TITLE: COMPREHENSIVE PLAN AMENDMENT NO. 03004, by the Director of Planning, at the request of the Public Works & Utilities Department and the Lower Platte South Natural Resources District, to adopt the Southeast Upper Salt Creek Watershed Master Plan as an approved subarea plan, and to amend the Land Use Plan to designate land as Green Space or Agricultural Stream Corridor along the 100 year flood prone corridor, on property generally located between Salt Creek and South 70th Street, from Yankee Hill Road to south of Saltillo Road.

Comprehensive Plan Amendment No. 03004 Southeast Upper Salt Creek Watershed Master Plan

Subject: *Southeast Upper Salt Creek Watershed Master Plan
Comprehensive Plan Proposed Amendment #4*

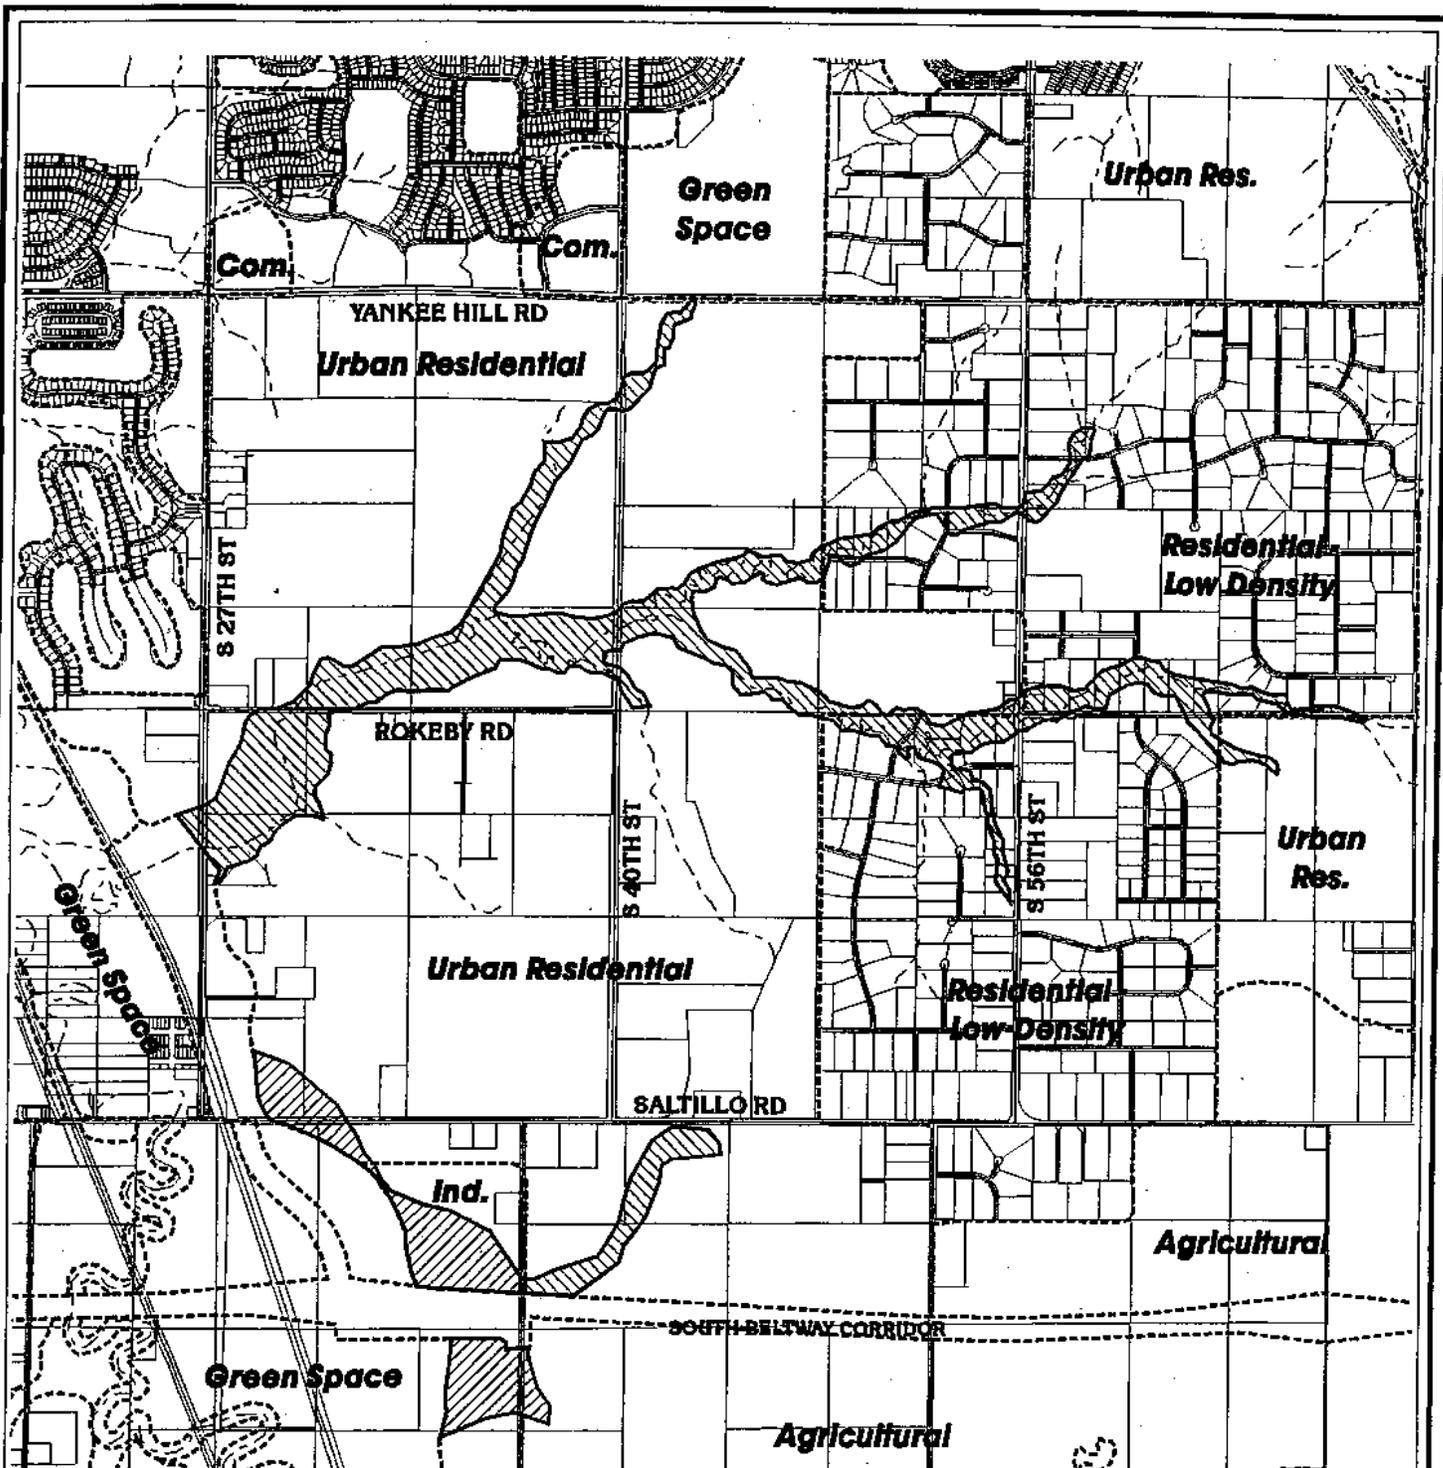
- 1) Amend the “Lincoln/Lancaster County Land Use Plan”, figure on pages F23 and F25, to designate as ‘Green Space’ and “Agricultural Stream Corridor” the 100 year flood prone area as shown on the attached map.
- 2) Add the “Southeast Upper Salt Creek Watershed Master Plan, 2003” to the list of approved subarea plans on Page F 156.
- 3) Add a new section to the end of the Watershed Management section on page F 80 as follows:

FIGURE: ES-1

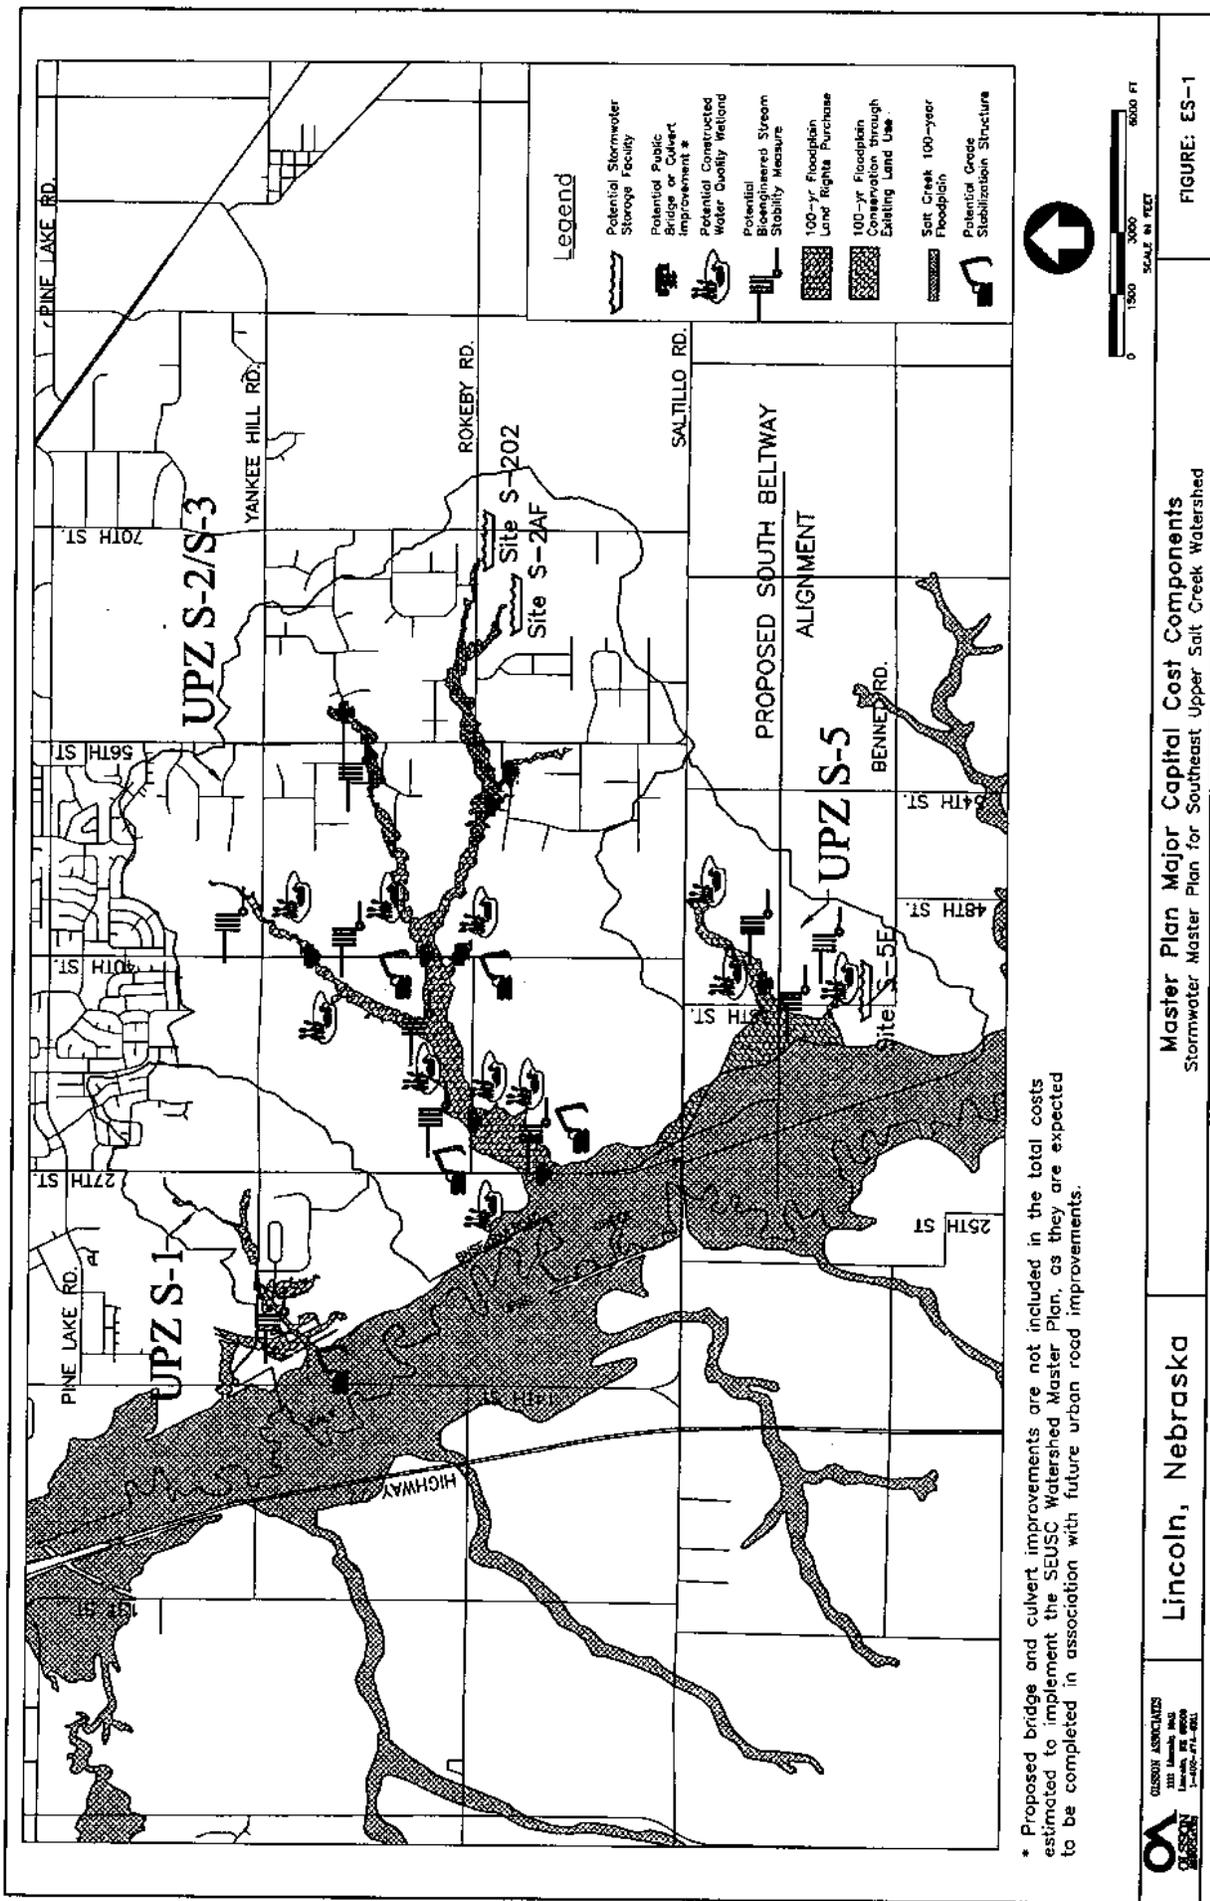
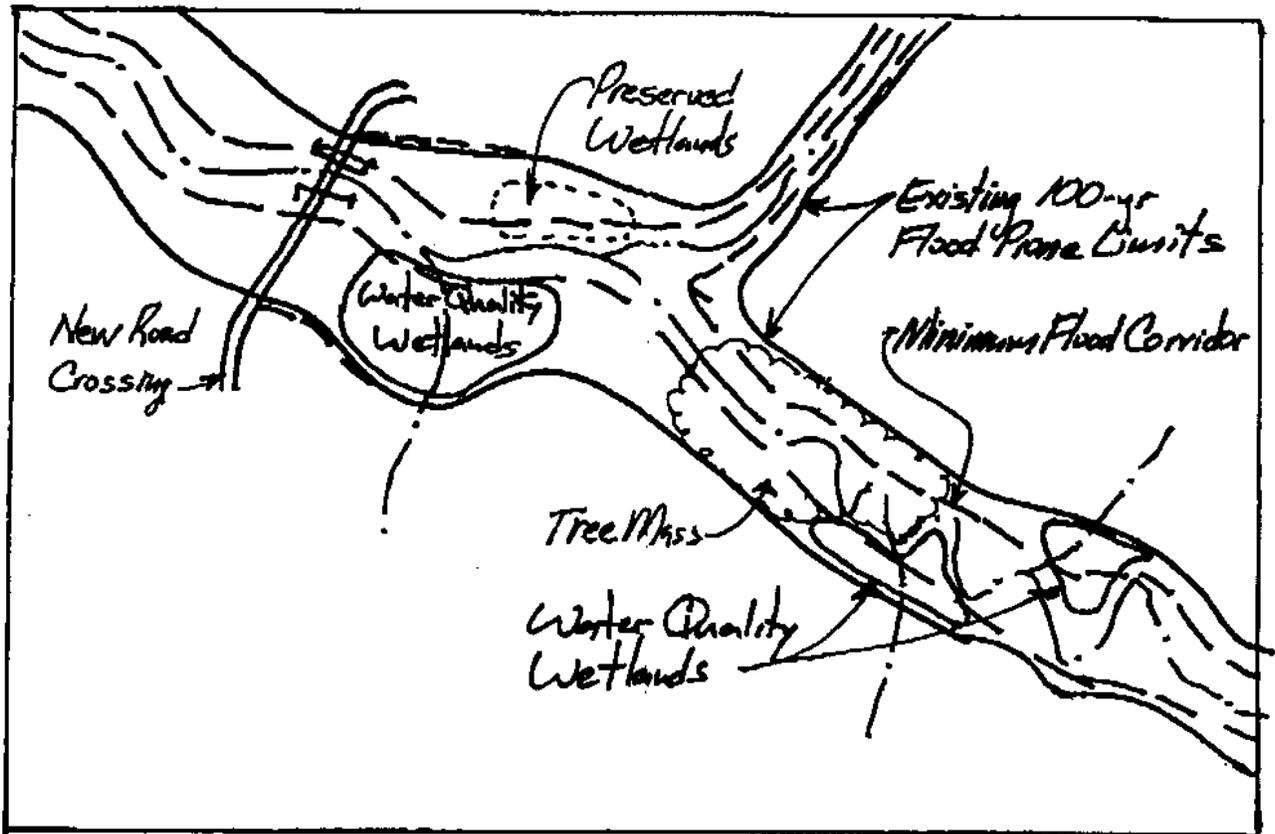
Impacts to water quality from encroachments into the 100-year flood prone area should be mitigated by construction of wetlands, or an alternative Best Management Practice (BMP) where similar water quality functions can be demonstrated. Wetland or BMP surface areas should be designed and constructed based upon the watershed area draining to the encroached flood prone area and should capture runoff volume of 0.5 inches from impervious surfaces. Design of the wetland or BMP, including plant selection, residence time, depth, and sediment trapping efficiency, should be based upon the guidelines of the Master Plan and the Lincoln Drainage Criteria Manual for maximum pollutant removal. These water quality measures are specifically intended to offset encroachments to the 100-year flood prone area and are in addition to water quality wetlands identified as Master Plan Major Capital Components on Figure ES-1.

Master Plan 'C'

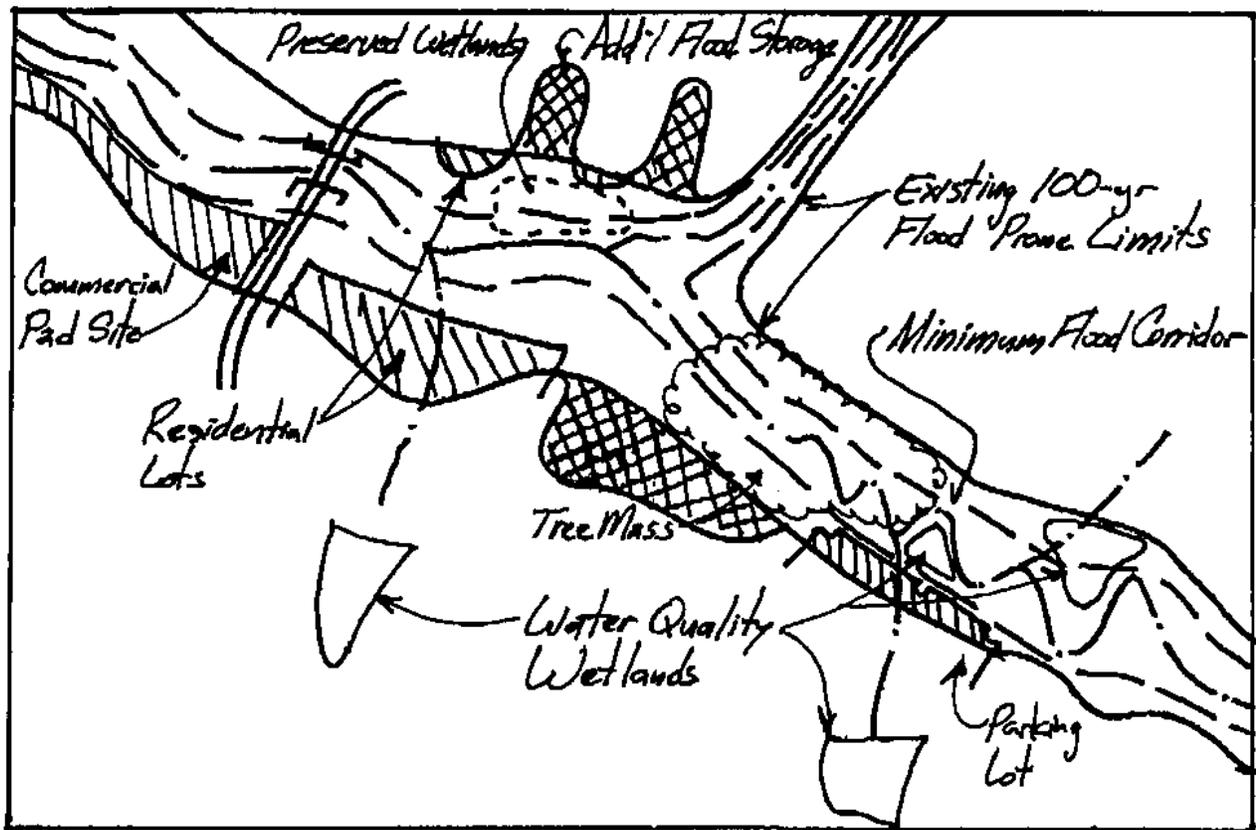
12. Concept diagrams for implementation of Master Plan "A" and Master Plan "C" are found on p.16, and the Southeast Upper Salt Creek Minimum Flood Corridor map is found on p.17.
